APPROVED DRAWINGS HAVE BEEN RED LINED INDICATING A CHANGE TO MEET THE OBC. PLEASE REVIEW ALL PAGES TO ENSURE YOU ARE PROPERLY INFORMED OF CHANGES.

Tice River Homes  
Legacy

**TOWNSHIP OF NORTH DUMFRIES  
BUILDING DEPARTMENT**

These Plans have been examined for Compliance with the Ontario Building Code requirements. A Building Permit has been issued, subject to any changes noted, under the condition that the building will be constructed in accordance with the code.

FRONT ELEVATION 'A'

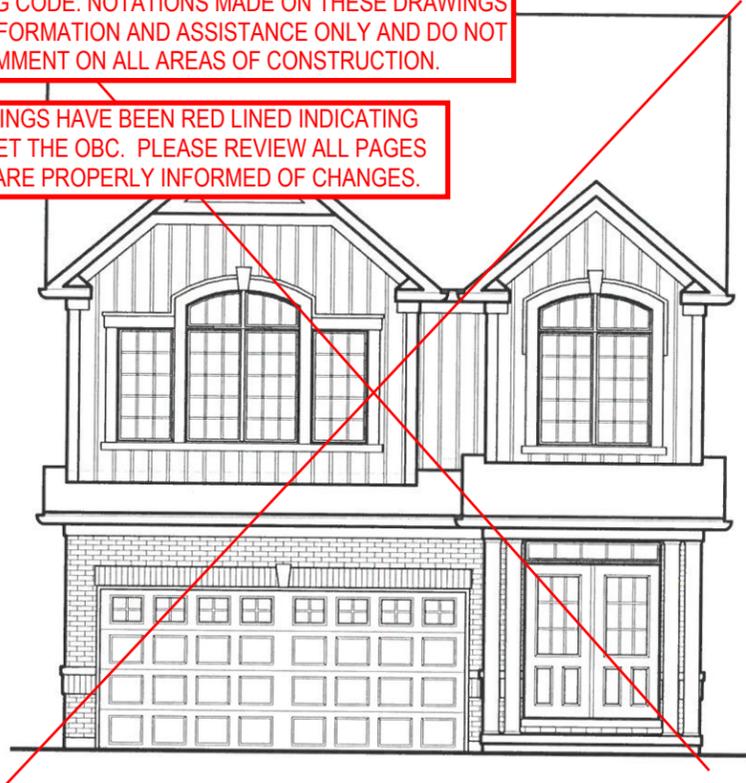
CALL FOR INSPECTION OF EXCAVATION CRIBBING BEFORE POURING ANY CONCRETE

ANY MODIFICATIONS TO GRADING SHALL NOT ADVERSELY AFFECT NEIGHBORING PROPERTIES.

FINAL GRADING CERTIFICATE REQUIRED BEFORE FINAL INSPECTION SIGN-OFF

**BASEMENT PLAN ELEV. 'A' & 'B'**

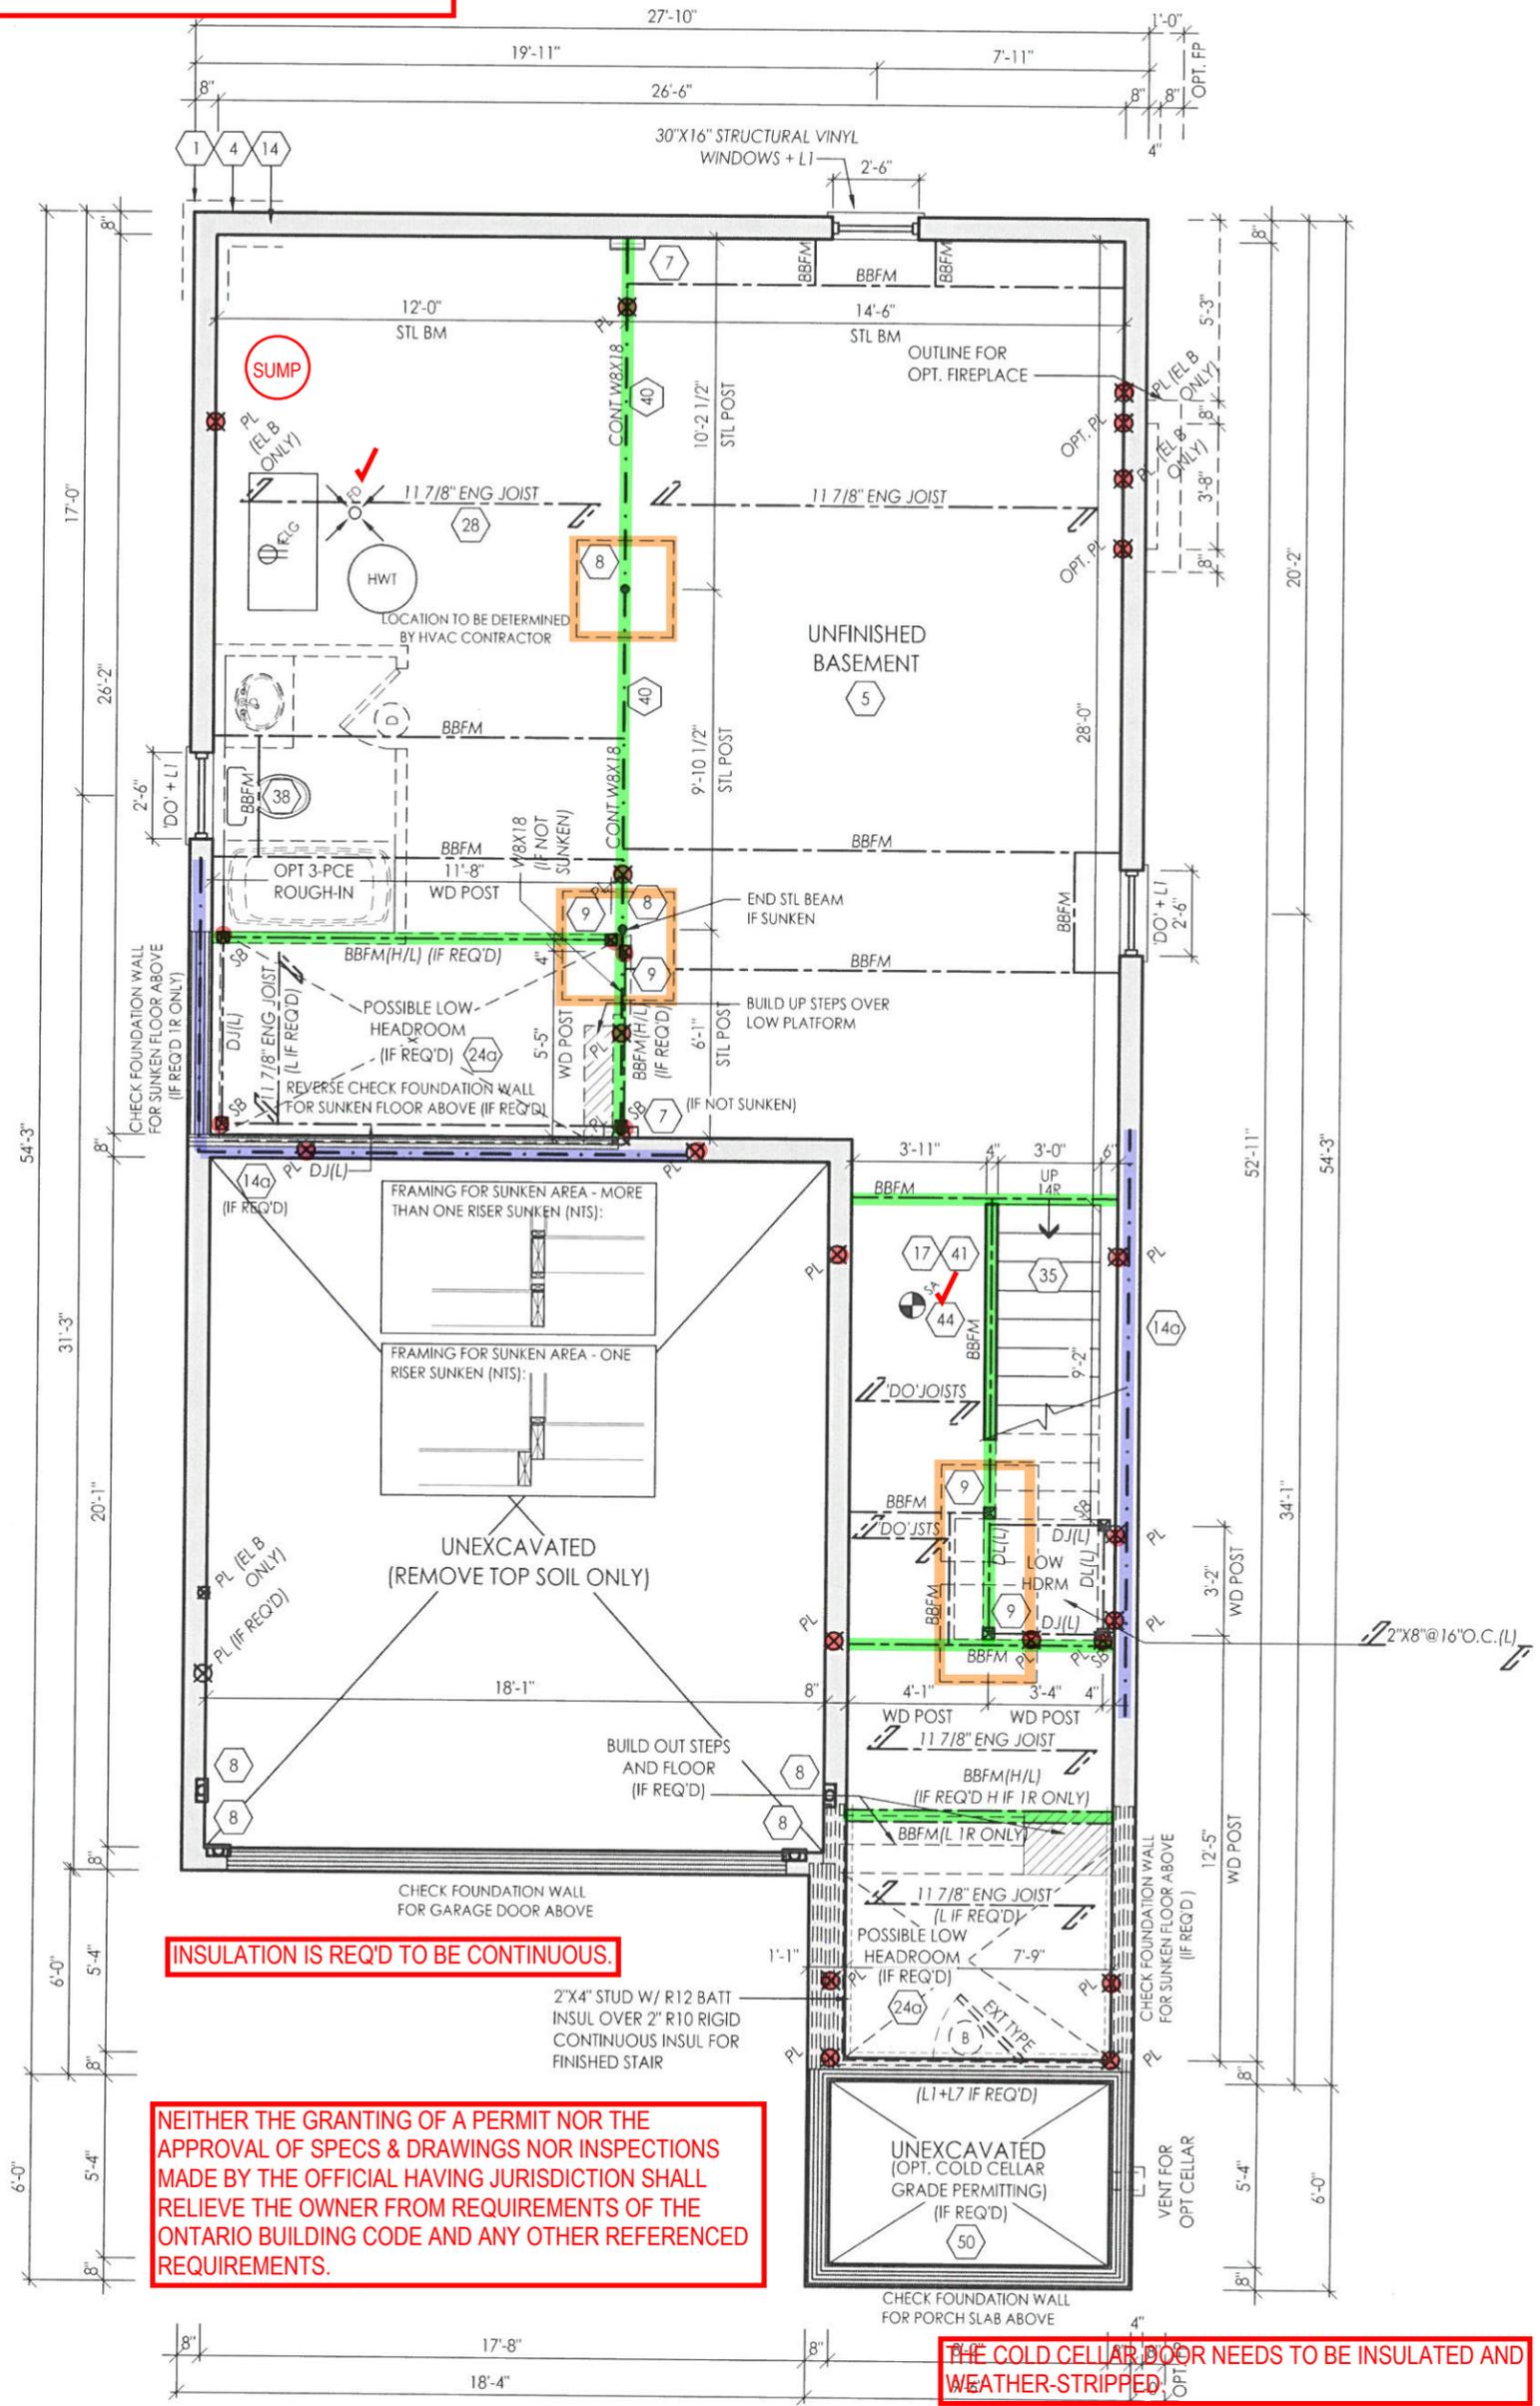
**A SEPARATE BUILDING PERMIT WILL BE REQUIRED TO FINISH THE BASEMENT.**

**INSULATION IS REQ'D TO BE CONTINUOUS.**

**THE COLD CELLAR DOOR NEEDS TO BE INSULATED AND WEATHER-STRIPPED**

**GROUND FLOOR ELEV. 'B'**

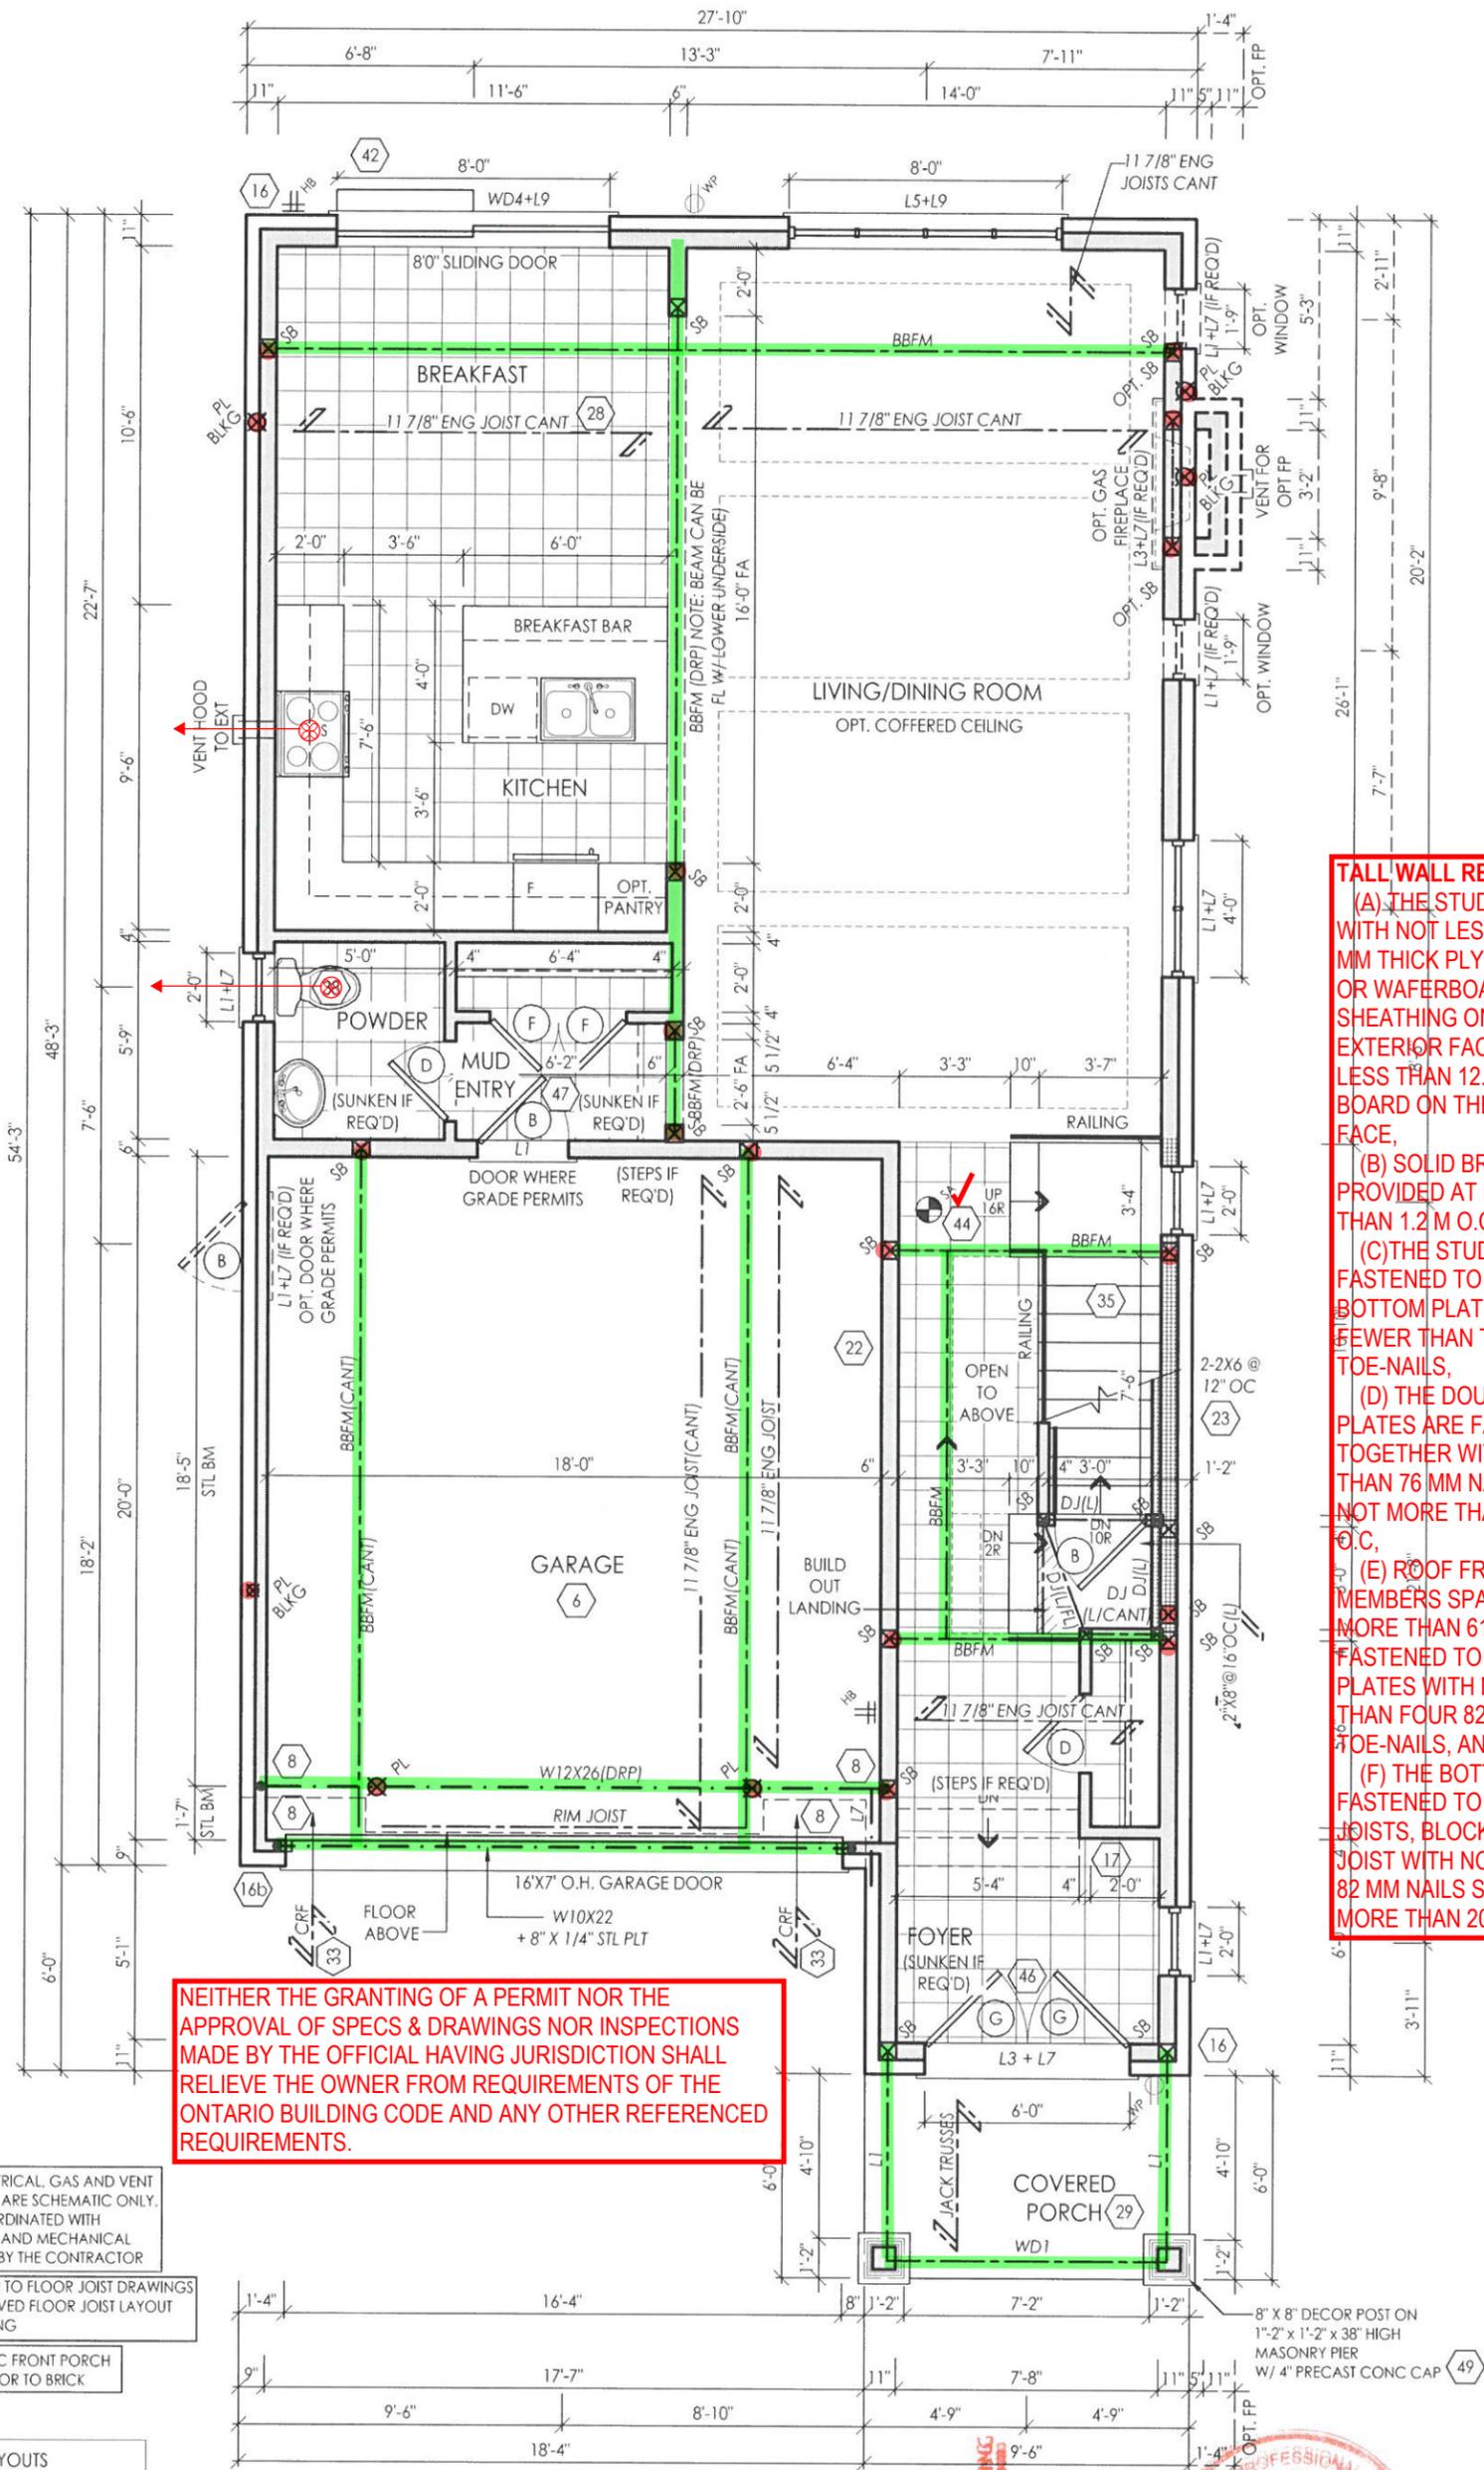
**TALL WALL REQUIREMENTS**

(A) THE STUDS ARE CLAD WITH NOT LESS THAN 9.5 MM THICK PLYWOOD, OSB OR WAFERBOARD SHEATHING ON THE EXTERIOR FACE, AND NOT LESS THAN 12.5 MM GYPSUM BOARD ON THE INTERIOR FACE,

(B) SOLID BRIDGING IS PROVIDED AT NOT MORE THAN 1.2 M O.C,

(C) THE STUDS ARE FASTENED TO THE TOP AND BOTTOM PLATES WITH NO FEWER THAN THREE 82 MM TOE-NAILS,

(D) THE DOUBLE TOP PLATES ARE FASTENED TOGETHER WITH NOT LESS THAN 76 MM NAILS SPACED NOT MORE THAN 200 MM O.C,

(E) ROOF FRAMING MEMBERS SPACED NOT MORE THAN 610 MM ARE FASTENED TO THE TOP PLATES WITH NO FEWER THAN FOUR 82 MM TOE-NAILS, AND

(F) THE BOTTOM PLATE IS FASTENED TO THE FLOOR JOISTS, BLOCKING OR RIM JOIST WITH NOT LESS THAN 82 MM NAILS SPACED NOT MORE THAN 200 MM O.C.
